# HydroQuest

**Consistency Review of the US Army Corps of Engineers New York  
District January 2016 report titled Mamaroneck & Sheldrake  
Rivers, New York Flood Risk Management - General Reevaluation  
Report (GRR) for the Village of Mamaroneck (Draft Main Report).**

**March 20, 2016**

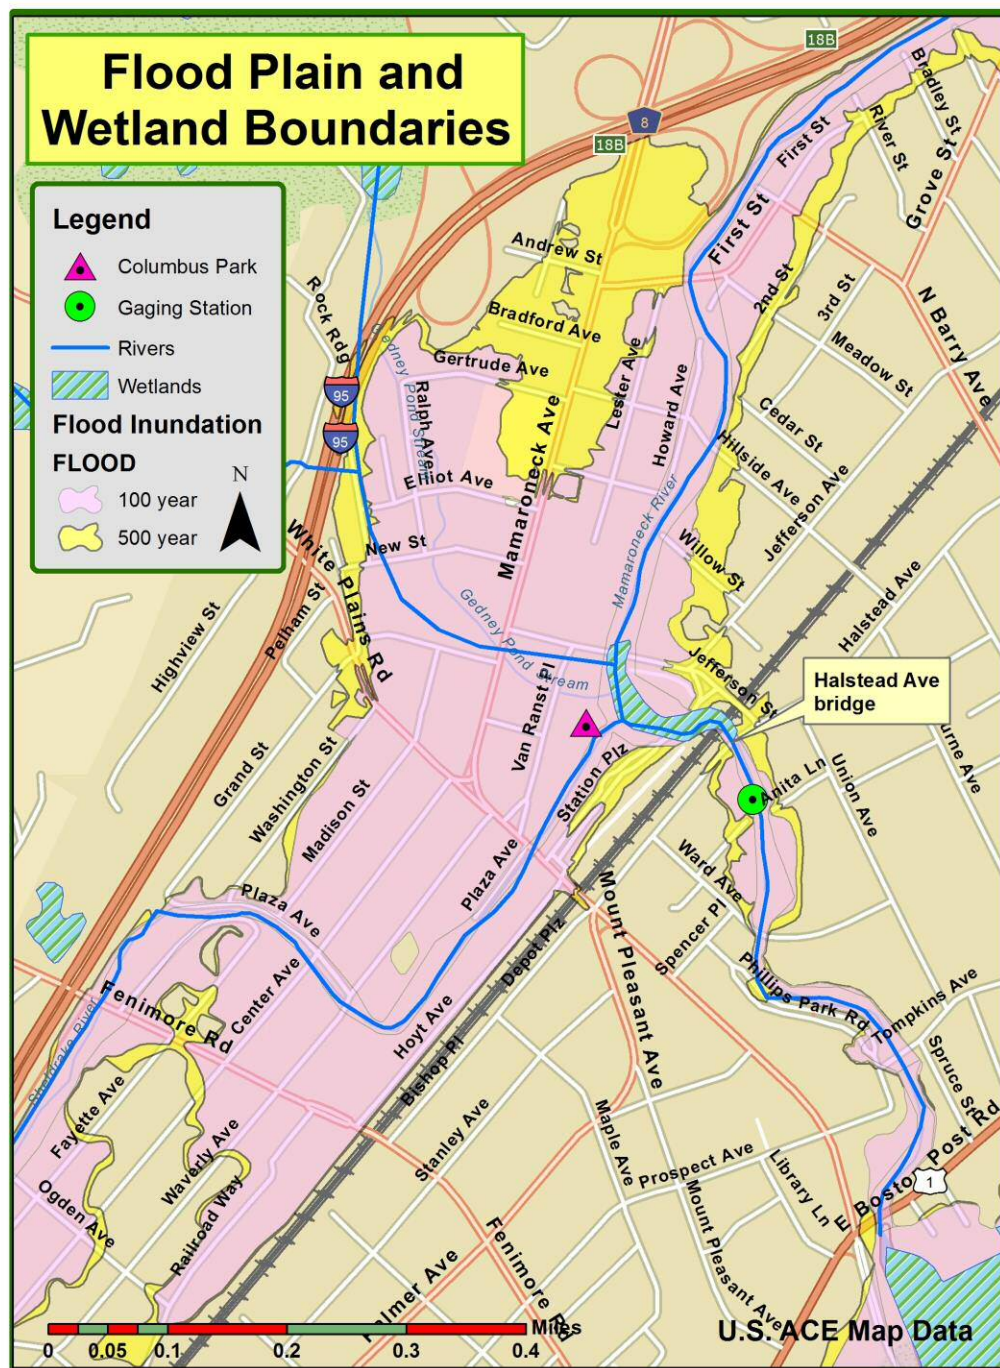
**Non-consistent issue:** Alternative 1Z will alter the integrity of the wetland situated at the confluence of the Mamaroneck and Sheldrake rivers (see Figure 2).

Figure 2. Limited channel cross-sectional areas beneath bridges situated down river of the confluence of Mamaroneck and Sheldrake rivers are not sufficient to convey major floodwaters. In response, floodwaters back up into the Village of Mamaroneck. Flooding dating back to at least 1877 results from these constrictions. Note the wetland that would be compromised with the current Alternative 1Z plan. This is not consistent with LWRP Policy 44.

Whatever floodwater mitigation plan is ultimately selected, it must “unplug” the hydrologic bottleneck that occurs as floodwaters incident to channel constrictions at bridges back flood portions of the Village of Mamaroneck. There are three options that stand out as worthy of consideration. These are 1) bridge removal and/or bridge rebuilding designed to provide increased channel cross-sectional areas to accommodate 100-year floodwaters, 2) major channel deepening beneath constricting bridges conducted to not undermine structural integrity, and 3) some form of partial water diversion designed to reduce floodwater volume. [It is difficult to envision how the ACE-proposed culvert, model-optimized through the railroad parking area and ending upriver of the river bottleneck, will not be inundated by floodwaters.]

The second option (i.e., channel deepening and widening) would require an increase in channel cross-sectional area beneath the Halstead Avenue bridge of some 25<sup>+</sup> percent greater than the current cross-sectional area (see Figure 3 below: *Channelization of Mamaroneck and Sheldrake Rivers: Lateral and Vertical Hydraulic Constraints*). While additional sub-bridge survey is required, this equates to about three feet of needed depth, assuming that the existing sub-bridge support walls are left intact. This appears to be the current Army Corps of Engineers approach to addressing large floodwater volumes that regularly back flood behind the Halstead Avenue bridge. Implementation of this option with continuous channel deepening and widening upriver of the bridges would result in a reduction/drop in river base level throughout all channel deepened reaches. As proposed, this would result in major disruption of upriver aquatic ecosystems, with a concurrent drop in local aquifer levels and river gradients.

# Channelization of Mamaroneck and Sheldrake Rivers: Lateral and Vertical Hydraulic Constraints

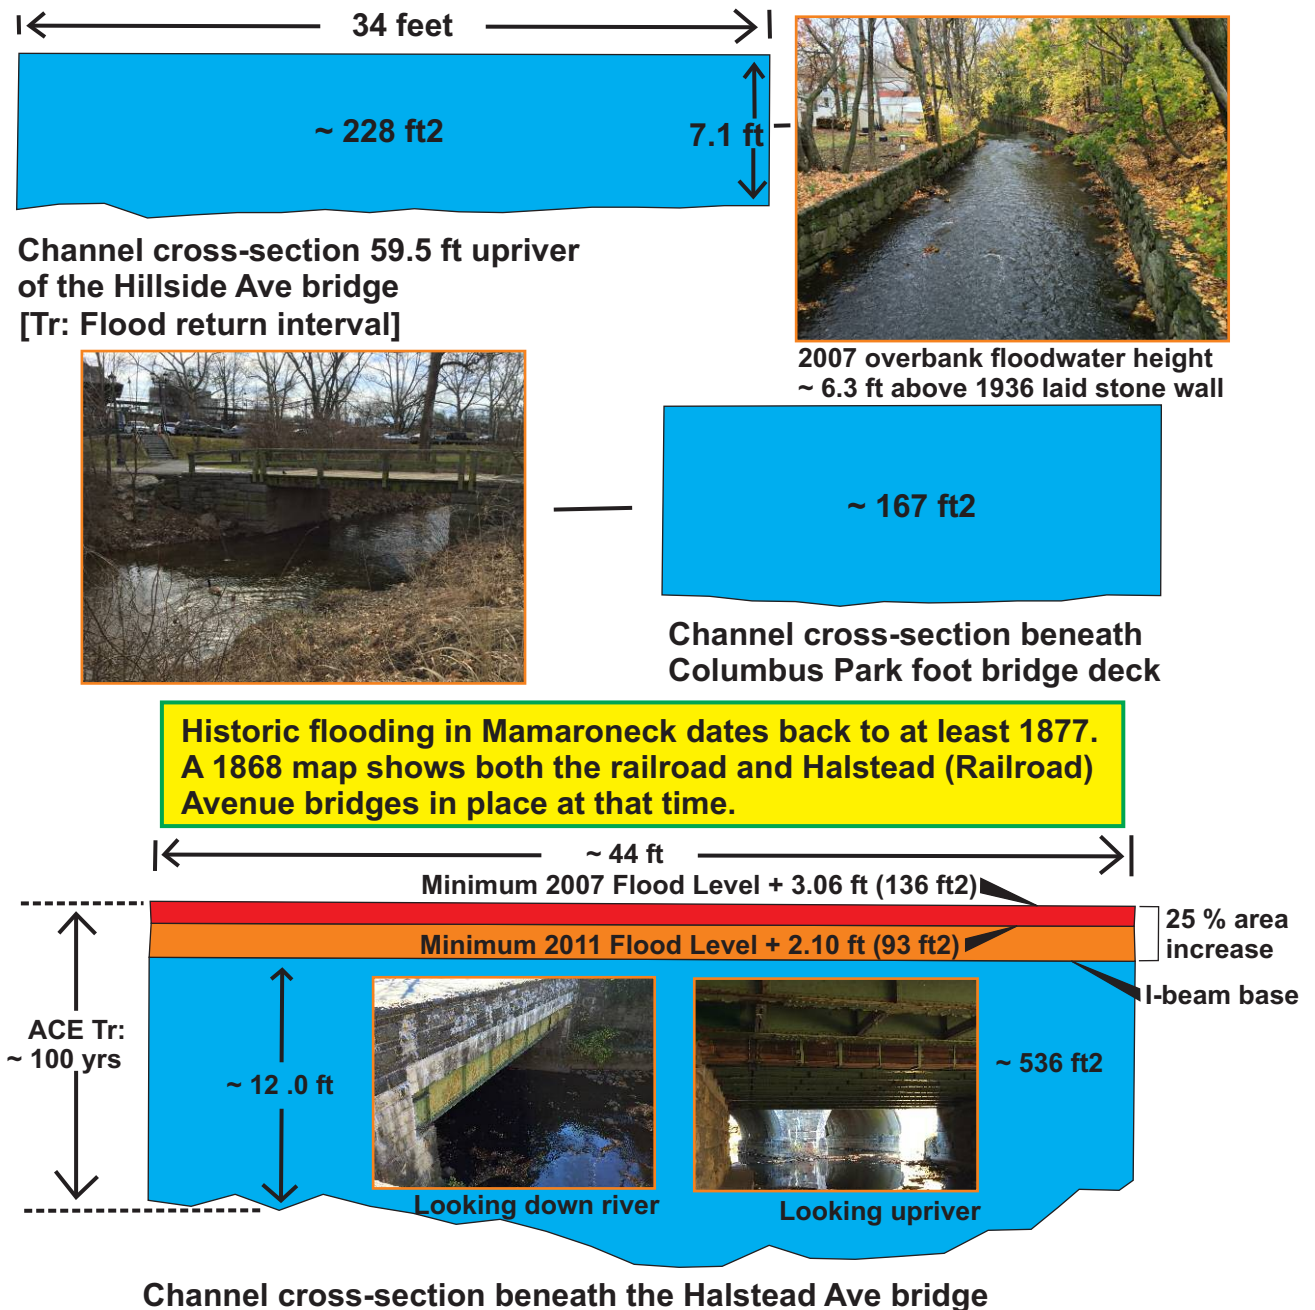
Significant portions of both the Sheldrake and Mamaroneck rivers have been extensively channelized coincident with building and bridge construction. This has reduced the areal extent of the natural floodplain and increased river velocity. Riprap and cement walls now laterally constrain river flow until floodwater flows overbank into adjacent areas. Low bridges have served to both laterally and vertically constrain channel cross-sectional areas. The hydraulic response to this is back flooding upriver of low bridges, inclusive of the Halstead and Ward's avenues bridges. Calibration against flood levels depicted in 2011 and 2007 photographs reveal the damming effect of such bridges (e.g., Halstead Ave. above). Flood levels artificially elevated behind bridge dams compound upriver flooding impacts above normal flood levels. Flood level reduction requires increasing channel cross-sectional areas, especially under bridges, to accommodate flood flows. HydroQuest graphic.

Figure 4. Log-Normal distribution provides the best fit of the ACE-based annual peak Flow values examined and generated for the Mamaroneck River near Halstead Avenue.

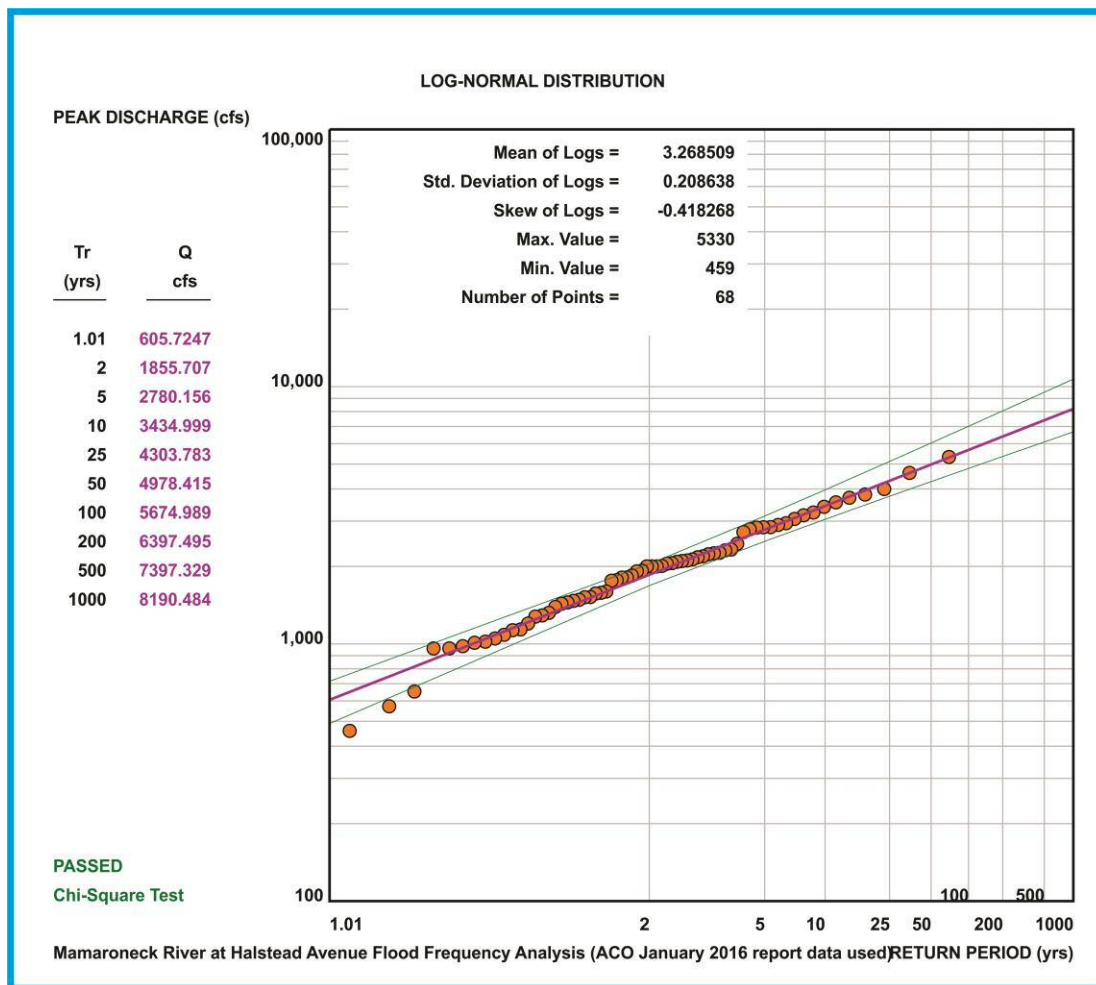
As part of this hydrologic work, the ACE upwardly increased and updated 30 of the 50 recorded annual peak values recorded on the Mamaroneck River, upward by as much as an additional 150 percent. The remaining 18 of 68 annual peak flow values used by ACE in their flood return (Tr) analysis were obtained indirectly from other watersheds using hydrologic means. This new, largely modeled, data set was then used to reconstruct what the peak flow value (Q in cubic feet per second [cfs]) was for the April 16, 2007 flood event (5330 cfs) and then, in turn, assess what the discharge is of a 100-year flood event.

Based on this work, the ACE determined that the largest flood of record (April 2007) was, statistically, a one in 100 year flood event. To assess other Mamaroneck floods of record, HydroQuest used the ACE annual peak flood values discussed in the paragraph above and conducted a flood frequency analysis. Of the four statistical methods used (Gumbel, Log-Pearson Type III, Log-Normal, Normal), the Log-Normal Distribution provided the best fit of the ACE data (Figure 4). Appendix A (attached) presents this analysis.
